Project Reference: BGL000285

Attention: The Expert Panel for Application FTA170 - Alternative to the Brynderwyn Hills

Alternative to the Brynderwyn Hills Fast-Track Consent – Initial Geotechnical Review and Gap Analysis

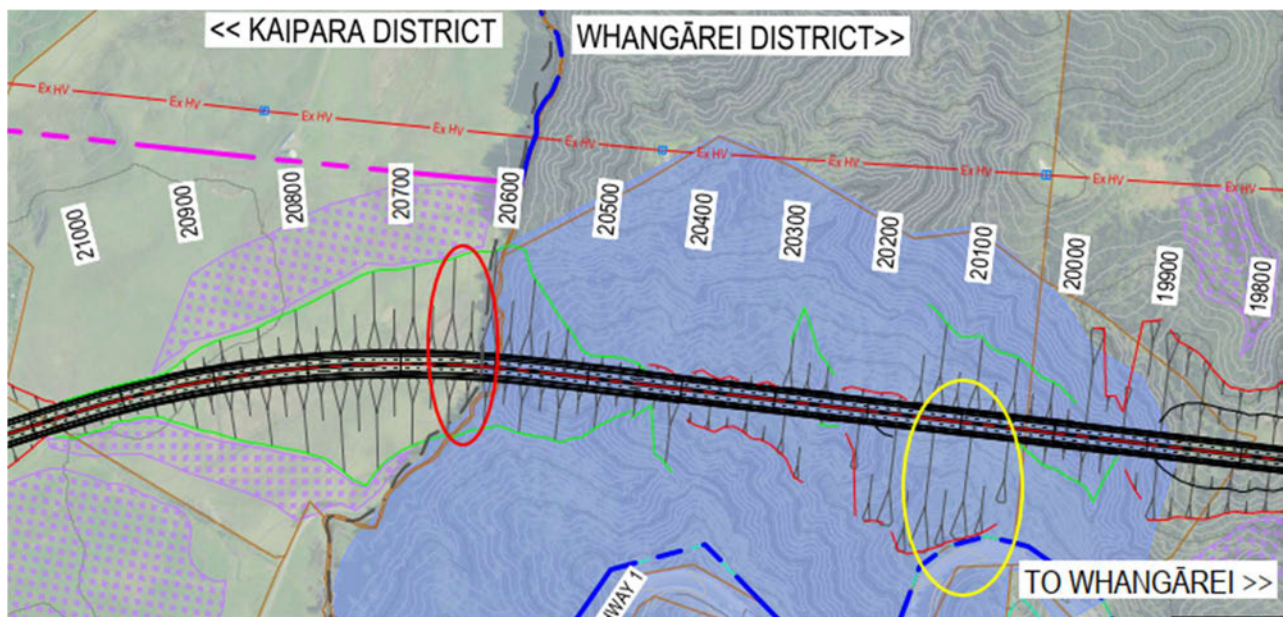
For example, as shown in Figure 1 between Chainage 20600 and 20900, fill up to 50 m high is proposed on Northland Allochthon material close to the designation boundary to the north. Large geometry changes (i.e., cut/filling) on Northland Allochthon can result in widespread instability that can extend well beyond the earthworks area.

Secondly, as shown in Figure 1, there is a steep cut proposed in the Waipapa Group at Chainage 20100, in close proximity to the existing SH1 carriageway and designation boundary to the south.

Additionally, indicative spoil sites are scattered throughout the designation area, as shown on the drawings⁴, and many of these are near to the designation boundary. No fill heights have been provided for these spoil sites to assess the potential for slope instability that could lead to off-site effects, in particular, where these are located on Northland Allochthon.

The lack of any form of specific design for the 50 m high embankment at CH20600 is a significant omission given the risks of triggering slope instability in the foundation materials.
